Item Name: Crosstube Turning Detail

DART AEROSPACE LTD		Work Order: 147836
Description: Crosstube Assembly		Part Number: D407-667-145
Inspection Dwg: D407-667-145 Rev: C		Page 1 of 2

DRAWING NO. D407-667-145	TITLE CROSSTUBE ASS'Y (407 HIGH FWD)	REV. C	DART AEROSPACE LTD ENGINEERING ORDER		D.E.O. NO. D407-667-145-C-1	SHEET NO. SHEET 1 OF 1	SCALE NTS
DRAWN <i>Q</i>	CHECKED <i>ASS</i>	MFG. APPR. <i>IB</i>	APPROVED <i>WD</i>		DE APPR. <i>H</i>		
DATE 11.07.15	DATE 11.07.22	DATE 11.07.22	DATE 11/07/22		DATE 11.07.21

DRAWING NO. D407-667-145	TITLE CROSSTUBE ASS'Y (407 HIGH FWD)	REV. C	DART AEROSPACE LTD ENGINEERING ORDER	D.E.O. NO. D407-667-145-C-2	SHEET NO. SHEET 1 OF 1	SCALE NTS
DRAWN AJS	CHECKED <i>[Signature]</i>	MFG. APPR. <i>[Signature]</i>	APPROVED <i>[Signature]</i>	DE APPR. <i>[Signature]</i>		
DATE 12.08.02	DATE 12.08.02	DATE 12.08.02	DATE 12.08.02	DATE 12.08.02	DATE 12.08.02

C TURNING DETAIL

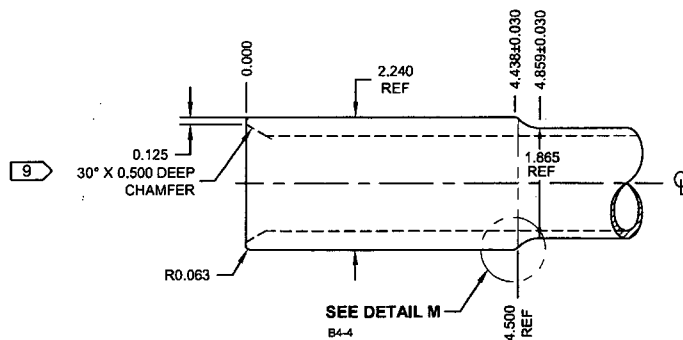
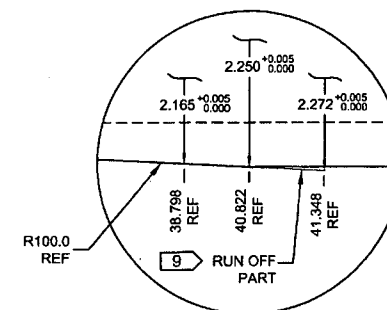
C	REVISE GENERAL NOTES/PART LIST (ZN D7-1); REORGANIZED VIEWS AND REFORMATTED DRAWING TO CURRENT STANDARDS. D3595-063-395 WAS D2856-400-694 (ZN D6-2 & A5-2); REMOVED REF. 7 ADD TOLERANCES (ZN C6-3, C4-3, D2-3); RELOCATED FLAG #6 (ZN A8-3) PER NCR 210; MOVED TURNING DETAIL & UPDATED TOLERANCE TO SHEET 4.	RF	08.11.06
B	ADD HOLES AND NUT PLATES FOR COMPATABILITY WITH BHT/AA SKUDTUBES	PH	05.07.26
A	NEW ISSUE	CP	02.05.08
REV.	DESCRIPTION	BY	DATE
DRAWN	RF	DART AEROSPACE LTD HAWKESBURY, ONTARIO, CANADA	
CHECKED	RF	DRAWING NO.	REV. C
MFG. APPR.	RF	D407-667-145	SHEET 1 OF 4
APPROVED	RF	TITLE	SCALE
DE APPR.	RF	CROSSTUBE ASS'Y (407 HIGH FWD)	NTS
DATE	08.11.06	COPYRIGHT © 2002 BY DART AEROSPACE LTD THIS DOCUMENT IS PRIVATE AND CONFIDENTIAL AND IS SUPPLIED ON THE EXPRESS CONDITION THAT IT IS NOT TO BE USED FOR ANY PURPOSE OR COPIED OR COMMUNICATED TO ANY OTHER PERSON WITHOUT WRITTEN PERMISSION FROM DART AEROSPACE LTD.

DETAIL P
BONDING STRAP INSTALLATION 2 PL

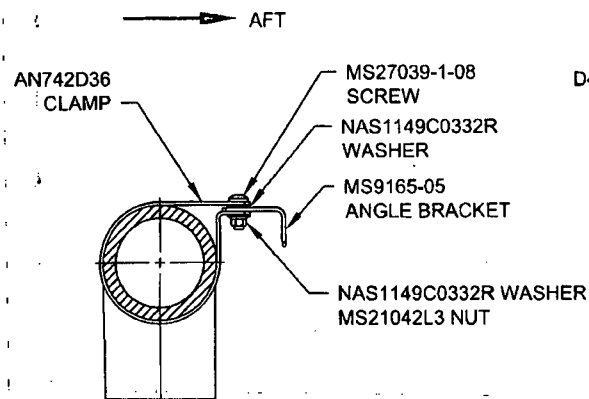
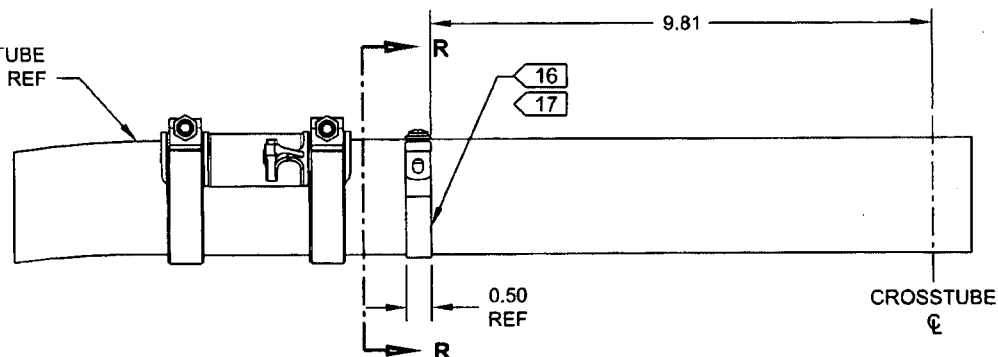
ADD ELECTRICAL GROUNDING STRAP

ITEM	QTY -145	PART NUMBER	DESCRIPTION
1	X	D407-667-145	CROSSTUBE ASSEMBLY (407 HIGH FWD)
<i>[Lightning Bolt Symbol]</i>			
10	2	AN742D36	CLAMP
11	2	MS9165-05	ANGLE BRACKET
12	2	MS21042L3	NUT (OR MS21042-3)
13	2	MS27039-1-08	SCREW
14	4	NAS1149C0332R	WASHER (OR AN960C10L)

- 16) MASK AREA UNDER CLAMP PRIOR TO PAINTING
- 17) SEAL EDGES WHERE AN742D36 CLAMP MEETS WITH THE CROSSTUBE USING SIKAFLEX-241/-291 OR MIL-S-8802 CLASS B2 OR PROSEAL 890 SEALANT
- 18) PERFORM RESISTANCE CHECK TO ENSURE MAX RESISTANCE IS 10 MILLIOHMS
